September 19, 2018

Assessment Report

River Road: No. 6 Rd – Westminster Hwy, Richmond, BC

Figure 3. Point # 7 notes that the minimum distance from the edge of the roadway to apply a sharrow is 4ft (1.2m). National Association of City Transportation (NACTO) Urban Bikeway Design Guide (2014, p. 137)

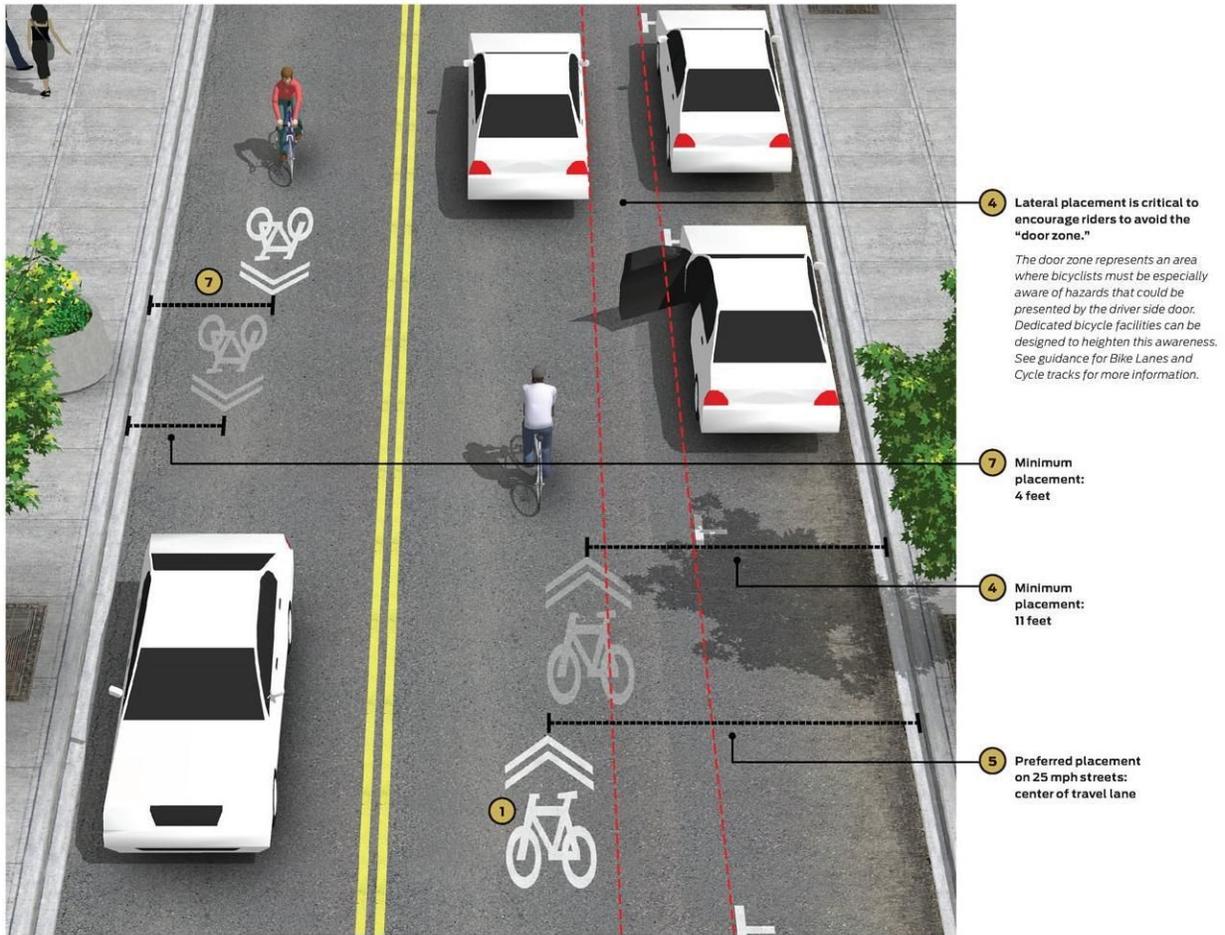
The BC Motor Vehicle Act (MVA) stipulates that a person riding a cycle “must ride as near as practicable to the right side of the highway” (183)(2)(c). But given the right side of the highway (or roadway) often contains cracks, potholes, and slippery sections, and that motor vehicles often cause gravel, dust, and debris to collect in these same areas, people cycling may shift towards the centre line to avoid these hazards. As such, it is therefore ‘practicable’ to bicycle at least one metre from the right side of the roadway (highway). The practicability of one metre is further justified in National Association of City Transportation Officials (NACTO) design guidelines, where the minimum distance to place ‘shared lane markings’ is approximately 1.2 metre (4ft) (see Figure 3 #7 on next page).

- 4.3 Installation of “Sharrows” along the entire length. Although not ideal, this would remind motor vehicles as to where to expect people cycling to be positioned on the road.
